MIDDLE VENTON DREWSTEIGNTON

HERITAGE APPRAISAL, IMPACT ASSESSMENT & SUGGESTED RESOLUTION IN CONSIDERATION OF UNAUTHORISED WORKS

Dartmoor National Park
Authority

September 2014

Figure 16b. Approved elevations application 0701/05, 0702/05

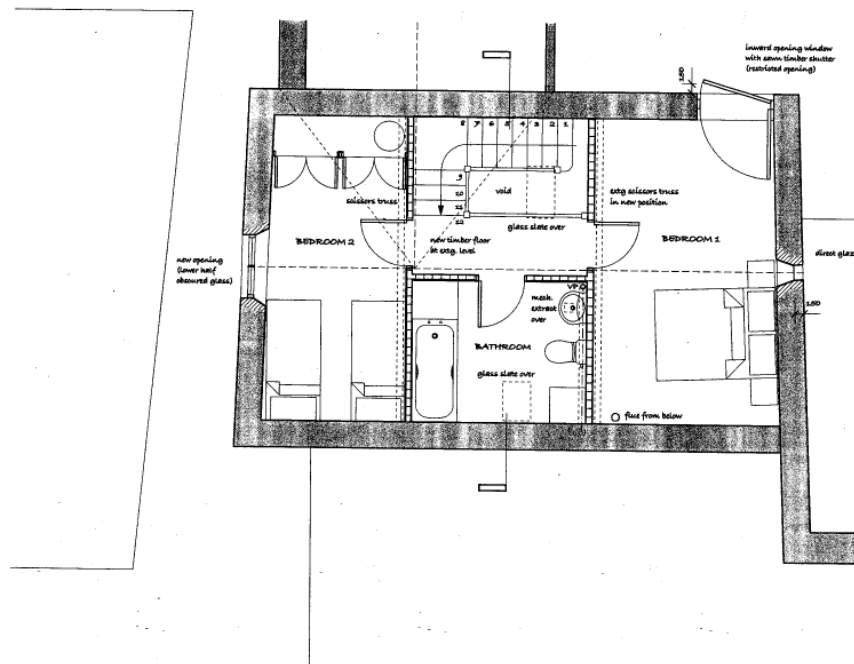
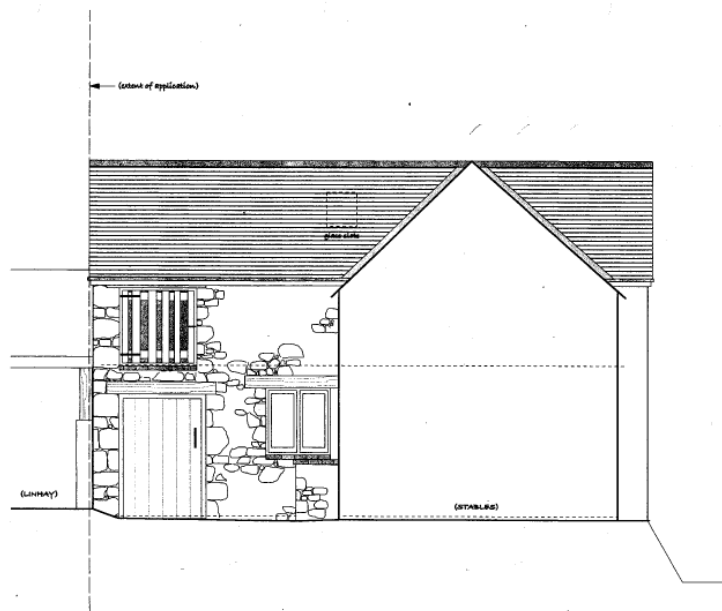
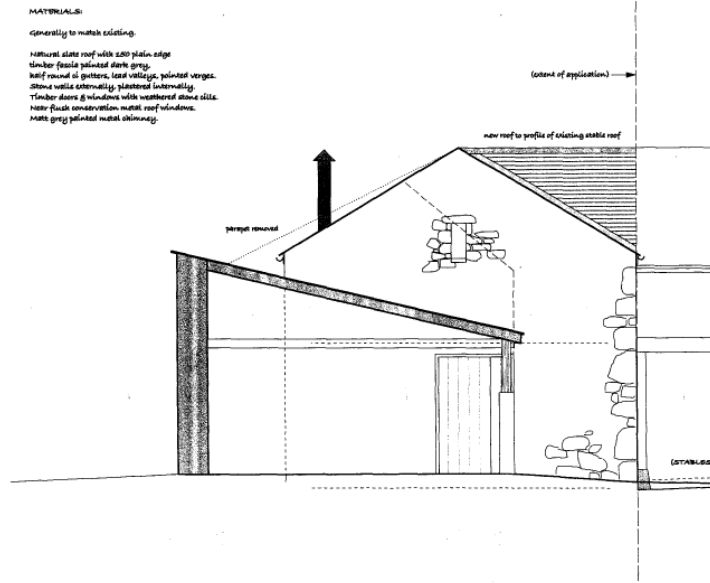
The approved scheme shows a shutter structure over the window, figure 17, this has not been fitted. **The first floor window that has been fitted as part of the overall conversion is not found to harm the heritage significance of Middle Venton and it is therefore recommended that the amendment is accepted by whatever means is considered appropriate.**
